(Virgil C. Summer Nuclear Station,
Unit 1)

}
}
}
Docket No. 50-395

JOINT AFFIDAVIT OF SANG BO KIM AND JOHN G. SPRAUL REGARDING
STRUCTURAL SIGNIFICANCE OF RECENT CADWELD ALLEGATIONS

Nomograph for sample with zero defects

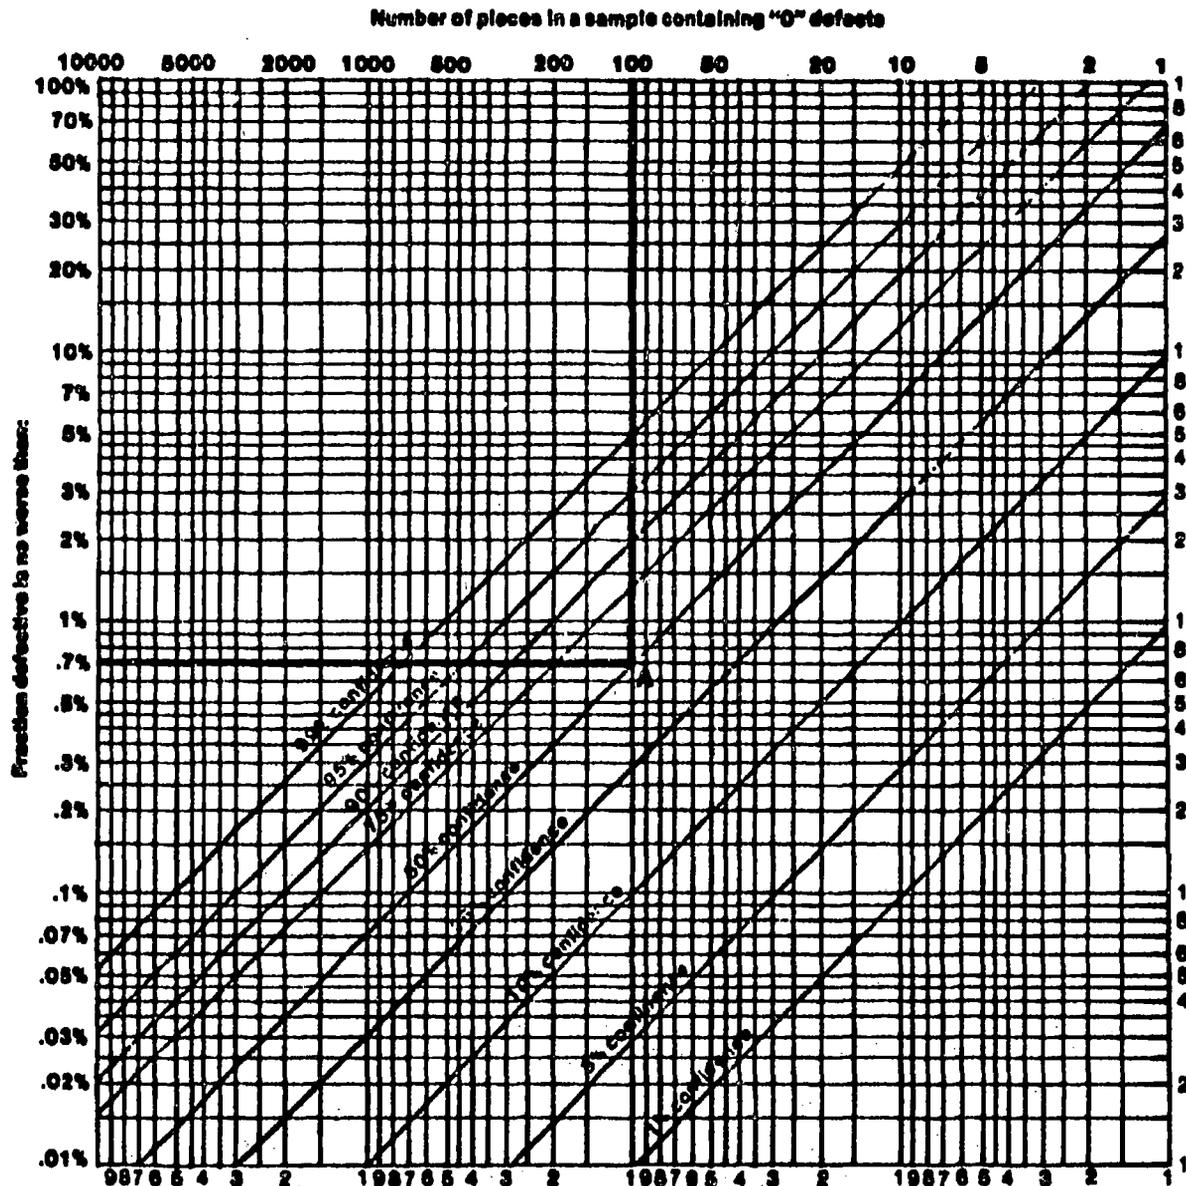
14. On the basis of these tests and the nomograph attached to this affidavit, the Staff reaches the following conclusions:
- (a) With 99% confidence, we expect a fraction of cadwelds with strength less than the minimum strength requirement that is no worse than 5%.

- (b) With 95% confidence, we expect a fraction of cadwelds with strength less than the minimum strength requirement that is no worse than 3%.
 - (c) With 90% confidence, we expect a fraction of cadwelds with strength less than the minimum strength requirement that is no worse than 2%.
